Quectel Wireless Solutions Co., Ltd

Ref: FCC Class II Permissive change for FCC ID: XMR201609EC21V
Original Grant Date: 9/30/2016
Applicant: Quectel Wireless Solutions Co., Ltd

This is to request a Class II permissive change for FCC ID: XMR201609EC21V, originally granted on 9/30/2016

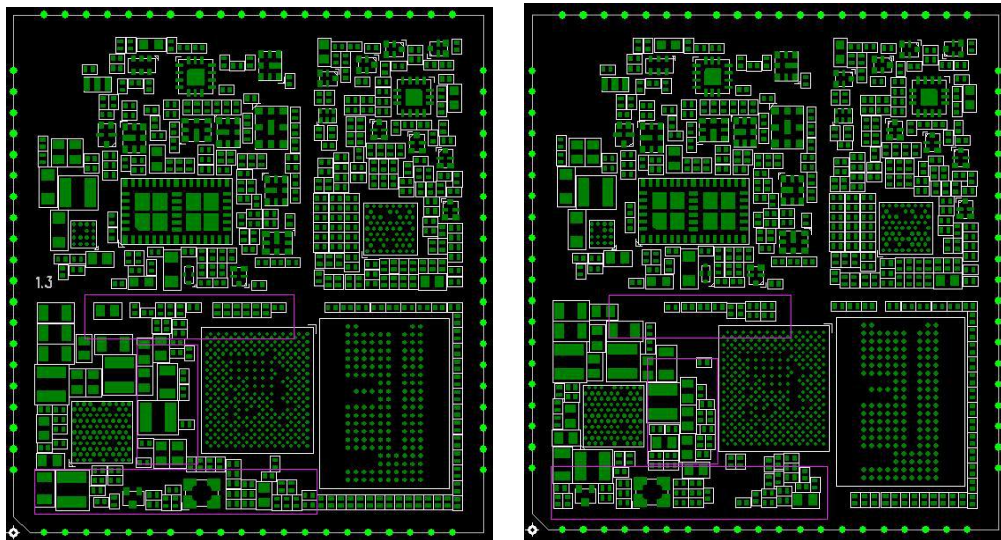
EC21-V, EC21-V MINIPCIE,
All above series models share the same hardware and software design. Here we need to update the hardware to improve power supply. There are some differences between **Certified HW Version A** and **New HW Version B** on PCB design which are some capacitors and resistors' location which used for BB. The details are shown as following pictures and table.

Designator	R1.0 Position (mm, mm)	R1.1 Position (mm, mm)
C0301	(5.8, 13.7)	(9.7,6.89)
C0306	(7.475, 13.75)	(10.84,7.81)
C0310	-	(8.707, 13.847)

C0307	(10.85, 11.1)	-
C0328	(8.85, 12.78)	-
C0227	(8.085, 11.15)	-
R0501	(16.35, 13.9)	(19.08, 13.91)
C0340	-	(9.23, 1.7)
C0402	-	(12.37, 4.25)
C0227	(8.085, 11.15)	(4.45, 13.58)
C0330	(9.1, 11.375)	(9.66, 5.12)
C0211	(2.575, 11.03)	(2.42, 12.35)
L0201	(2.35, 9.15)	(2.32, 10.45)
L0202	(8.925, 7.1)	(8.15, 7.94)
C0214	(1.91, 2.73)	(1.89, 4.05)
L0204	(3.62, 2.64)	(3.78, 3.97)
Y0101	(11.61, 2.45)	(7.45, 2.39)
Q0101	(7.36, 2.125)	(3.32, 2.12)
C0317	(15.46, 2.3)	(17.01, 1.87)

We hereby state that there is no any other internal difference between them and the change is layout part of power supply BB which won't affect the RF portions and the original RF data can be re-used.
